ADDENDUM NO. 2

To the Drawings and/or the Specifications for
Harford County Public Schools
Harford High School
Comprehensive Roof Replacement – CAG 25-1
Bel Air, Maryland

April 7, 2026

DRAWN BY: C.J.W.
 PROJECT NO.: 25097
 SHEET NO.: **M1.0**
 DATE: 03/15/2020

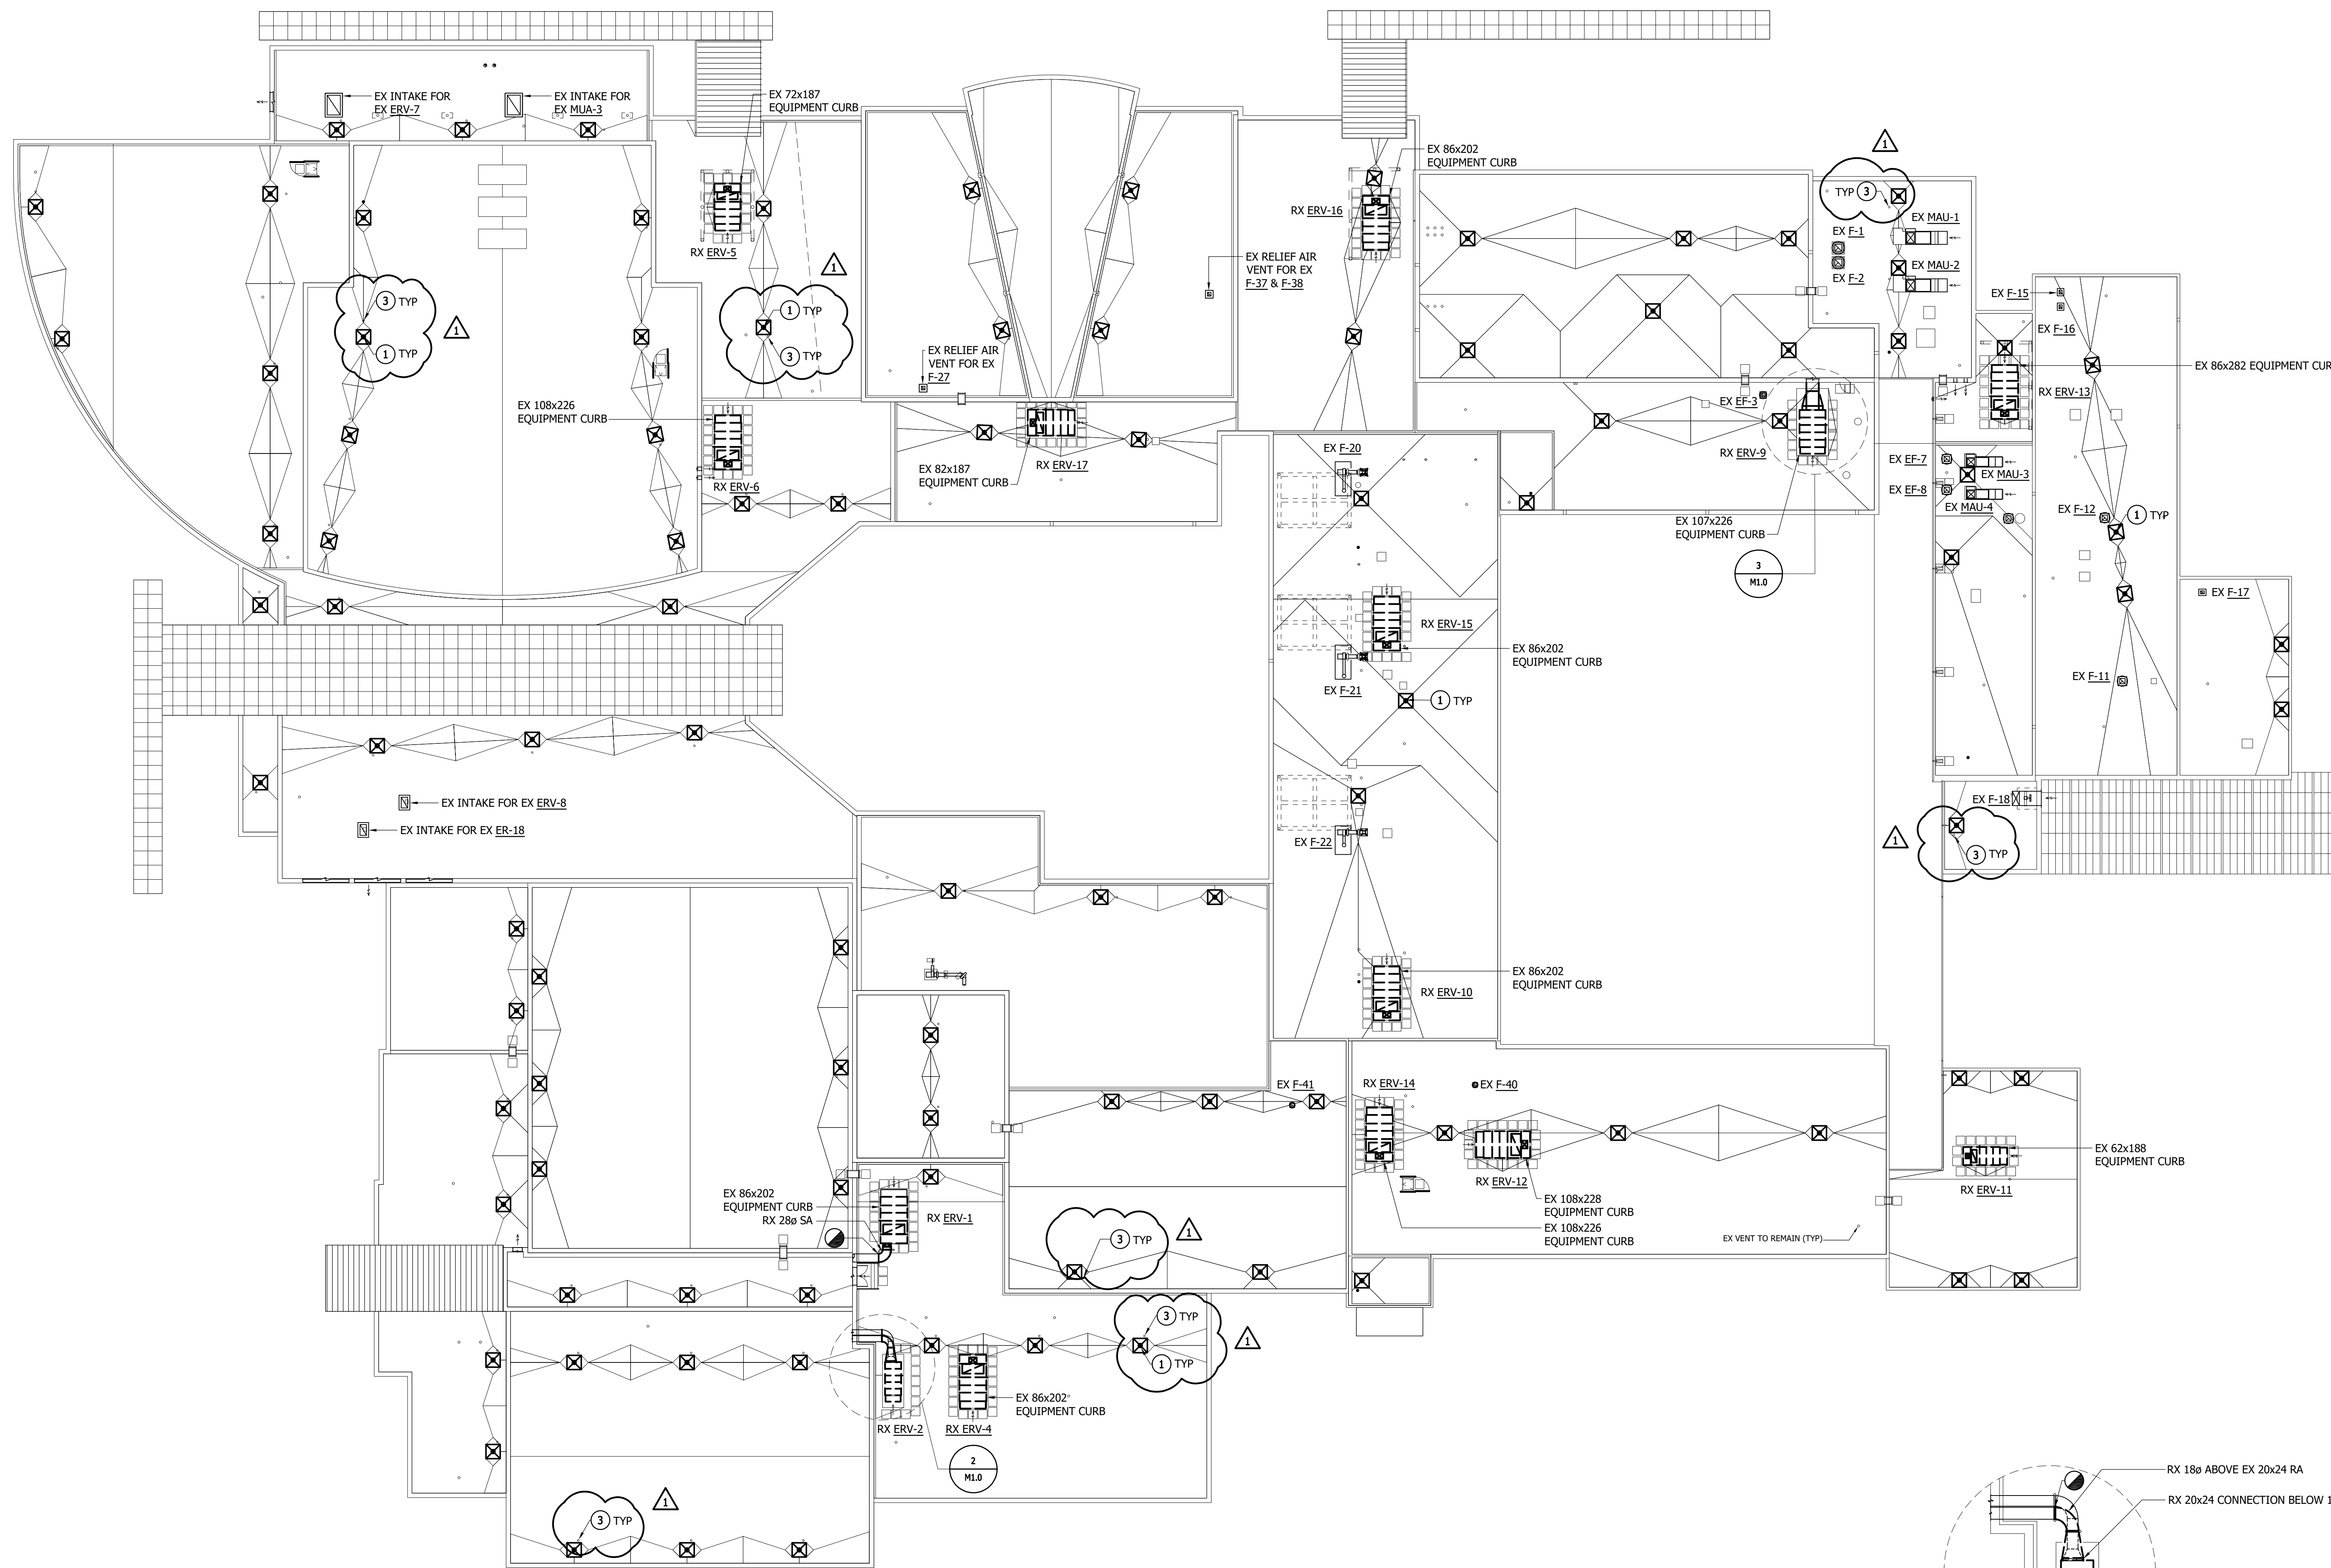
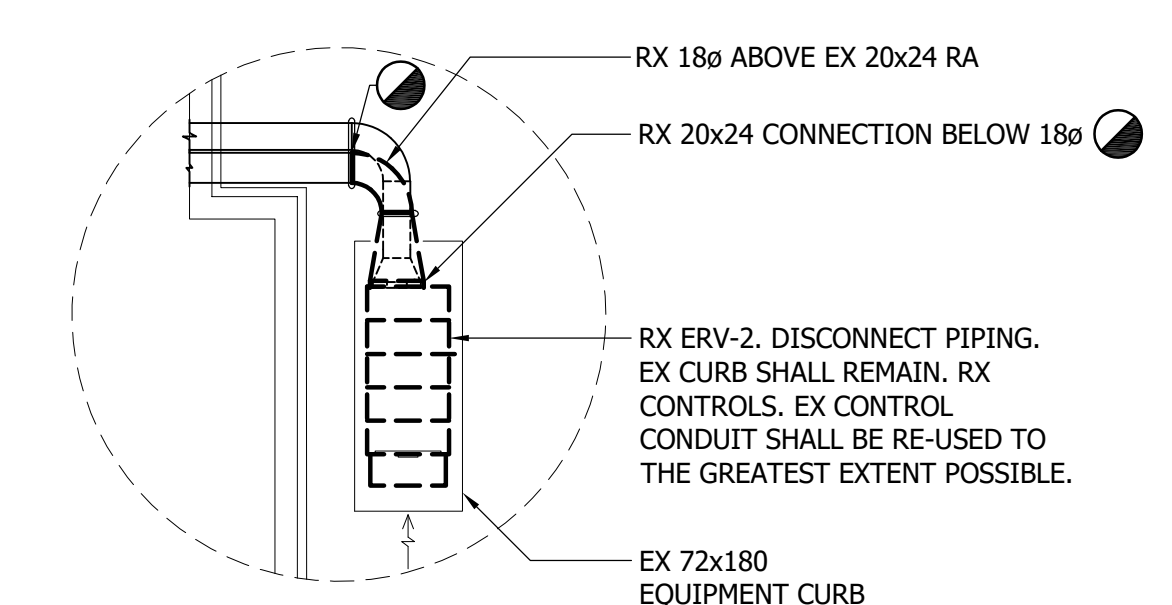
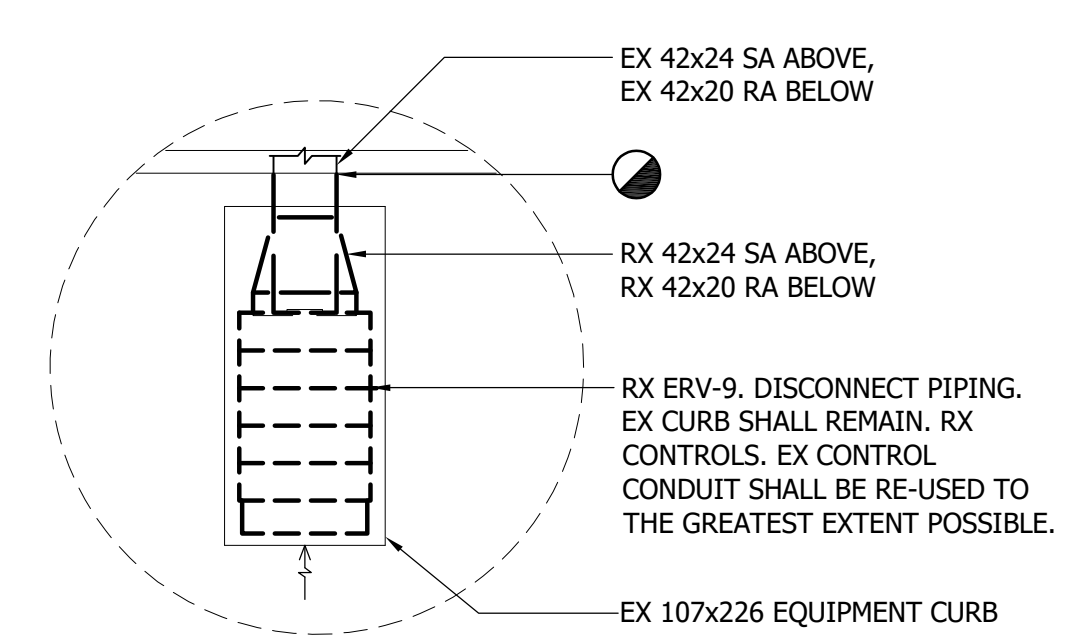
1. ADD Drawing Note 3 to Drawing 1.0 that reads "RX Secondary Roof Drain".
2. REVISE ERV-7 on Drawing M1.1.
3. ADD Rooftop Ductwork Notes to Drawing M2.0.
4. ADD Drawing Note 2 to Drawing 2.0 that reads "INSTALL SECONDARY ROOF DRAIN. PROVIDE ANY PIPE MODIFICATIONS REQUIRED TO CONNECT ROOF DRAIN OUTLET TO EXISTING STORM WATER PIPING. SEE ARCHITECTURAL DETAILS FOR ADDITIONAL INFORMATION.
5. REVISE ERV-7 on Drawing M2.1.
6. ADD DRAWING M4.1.

- ① RX PRIMARY ROOF DRAIN.
- ② DISCONNECT DUCTS, PIPING, AND CONTROLS FROM UNITS. EX CURBS WILL REMAIN.
- ③ RX SECONDARY ROOF DRAIN.
